PROJECT REVIEW REPORT

Project ID	1221
Project Name	Eglence I-II Hydroelectric Power Plant
Review Type	Crediting Period Renewal
Program(s)	VCS
Verification Period	NA
Project Proponent	Egenda Ege Enerji Uretim A.S.
Methodology	ACM0002: Grid-connected electricity generation from renewable sources, v21.0
VVB	RINA Services S.p.A.
Assessment Criteria	VCS Standard, v4.7
Date of First Issue	26/11/2024, 07/01/2025
Review Conclusion	Approved
Date of Final Issue	22/01/2025

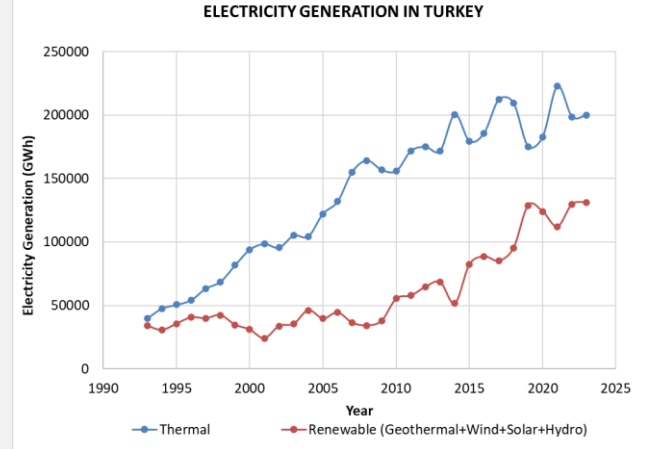
4. Discrepancy in reservoir area			
	<p><u>Issue</u></p> <p>There is a discrepancy in the reservoir area between the registered PD (CP1) and the CP2 PD.</p> <p><u>Action Required</u></p> <p>The VVB shall identify the causes and provide the assessment in the VR.</p> <p><u>Program Rule(s)</u></p> <p>Section 2.2, VCS Standard v4.7</p>	<p>Round 1</p> <p><u>VVB Response</u></p> <p>As explained under Section 1.1, due to change only in electromechanic equipment, the capacity of the Eglence I HEPP and Eglence II HEPP are revised to 43.50 and 27.2 MW, respectively. In this regard, the CAP_{PJ} parameter values for two plants are changed. The area of the reservoirs was measured from Google Earth and relevant images from Google Earth showing reservoir areas are verified. Accordingly, PD value is calculated. By the way during licensing process it is usual to make minor revisions according to mechanical changes of</p>	<p>Closed</p>

equipment.	
		<p><u>Verra Response</u></p> <p>The VVB clarified that the discrepancy in the reservoir area was due to electromechanical equipment changes, with updated PD values calculated based on verified Google Earth images. No further action is required. This finding is now closed.</p>
